Easier installation of the new SAF two-side axle lift for INTRA series with steel hanger brackets

Illustration of axle lift - 03 027 1278 01

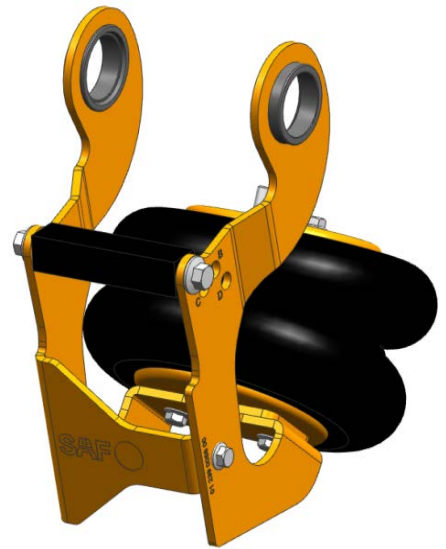
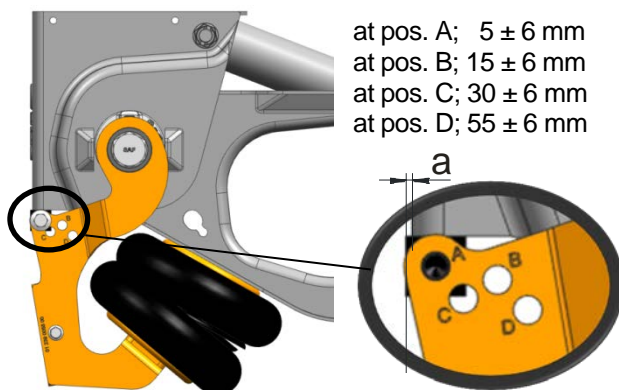
To lighten the installation of the two side axle lift, SAF-HOLLAND has redesigned the lift arms. Now with the new shaped lift arms, when installing, the lift arms are brought into position and **fixated on the side of the lift arm**.

This **optimized accessibility** with the screw on the side of the lift arm makes the installation faster and easier because there is only **one screw** needed. Other parts at the chassis (as a palette box) are not interfering anymore when mounting the lift.

- Also with the revised version the **assembly** of the two-side axle lift is done **without loosening and re-tightening the pivot bolt connection**.
- No conversion to the longer pivot bolt.
- During the optimization measurements the total weight has been **reduced** by 1 kg to 21 kg/axle.
- Well protected against corrosion by KTL coating.
- The lift arms can be painted over.

The necessary distance from lift to front side of the hanger bracket (a) has been shortened by 15 – 25 mm, depending on the position of the support bar.

End Q4 2015 will the new two-side axle lift with number 03 027 1278 01 replace the current two-side axle lift with number 03 027 1278 00. A combined installation of both lift systems is possible.
